**TECHNICAL BULLETIN**

FA-A-0286-A

**Production Discontinuation of Type QD75P/QD75D Positioning Module**

QD75P1, QD75P2, QD75P4, QD75D1, QD75D2, QD75D4

### 6.3 Transferring the Set Data of the QD75P/QD75D Using GX Works2

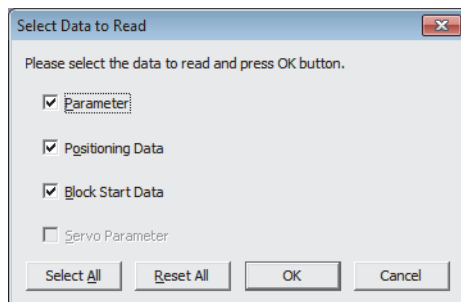
When GX Works2 is used, the set data of the QD75P/QD75D can be transferred to the QD75P□N/QD75D□N in the following procedure.

#### Saving the set data of the QD75P□/QD75D□ from [Save the Positioning Module Data...]

1. In the project view, select the QD75P□/QD75D□ from where the set data is transferred.
2. Go to [Project] ⇒ [Intelligent Function Module] ⇒ [Save the Positioning Module Data...].
3. Input the file name, and save the set data.

#### Reading the set data to the QD75P□N/QD75D□N from [Read from the Positioning Module Data...]

1. In the project view, select the QD75P□N/QD75D□N to where the saved data is transferred.
2. Go to [Project] ⇒ [Intelligent Function Module] ⇒ [Read from the Positioning Module Data...].
3. Select the name of the file saved in the above step, and open it. The following window opens.

4. Select the data to read and click "OK". The set data is read to the QD75P□N/QD75D□N.
